**RE: Additional Information Response for Planning Application Reg. Ref. SD22A/0428,
Warehousing Block B4, Site B, Aerodrome Business Park, Collegeland, Rathcoole, Co. Dublin.**

Applicant: De La Salle Limited

Please find the response to the additional information request dated 12 Jan 2023. This response is accompanied by the letters and drawings from consulting environmental scientist (JBA), landscape architect (JBA), arborist (Arbor-Care Ltd.) and Kavanagh Burke Consulting Engineers.

Figure 1. Extract from Flood Risk Assessment for Site R development. Planning Ref. SD21A/0140

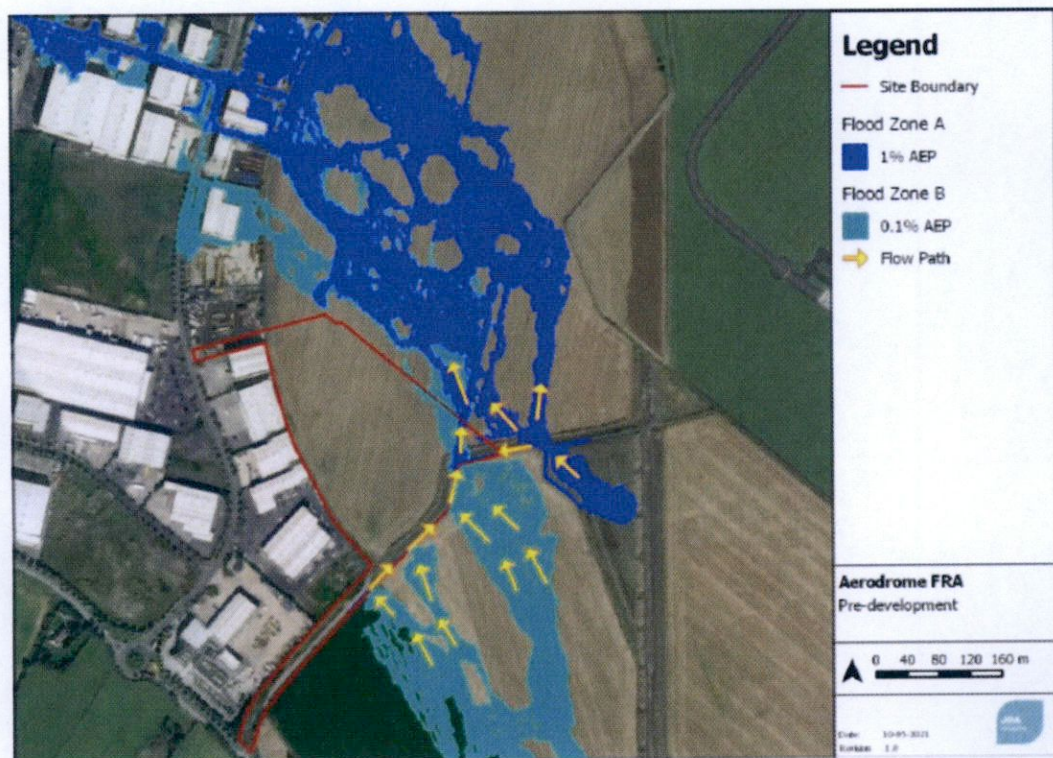
Item 5)

Part of the subject site is shown in flood zone B on the 0.1% Fluvial AEP Flood Depth Map available at floodinfo.ie. The estimated flood depths are between 0 and 0.25m for 1 in 1000y flood event. The proposed building floor level is set out at 95.0m AOD (min 0.51m above the adjacent road level at the front). The flood extents from Camac River were recently modelled in greater detail (using topographical surveys for surrounding ditches) for the now constructed Site R industrial development to the south and to the east of the Block B site. Site R planning Ref. SD21A/0140. Results of the remodelling and reassessment of the Camac River flood extents are presented in the chapter 4 of the flood risk assessment produced by JBA Consulting hydrologist for the Site R planning application. The report is showing that all 0.1% AEP flows are being conveyed by the existing ditches around southern and eastern boundaries of Site R and that no flood water enters Site B in Aerodrome Business Park. See the extract from the FRA report below or refer to the original Site R FRA available on South Dublin County Council Planning Website.

The flood extents are displayed in Figure 4-1, showing there is minor flooding at the eastern corner of the site for the 1% AEP event (Flood Zone A) and the 0.1% AEP event (Flood Zone B), placing the majority of the site within Flood Zone C. The hydraulic modelling confirms the overland flows from the Camac River are shallow and are easily conveyed by the site ditch. The flows are then diverted in a northerly direction across the eastern corner of the site.

The results for the 1% AEP event are similar with the CFRAM study. However, CFRAM mapping identifies higher flood extents within the site boundary for the 0.1% AEP event, as the local ditch was modelled using only LiDAR data which does not capture the full channel capacity due to obstruction caused by vegetation.

As stated previously, the JBA model used survey data information for the site ditch, allowing for a better representation of the channel within the model.
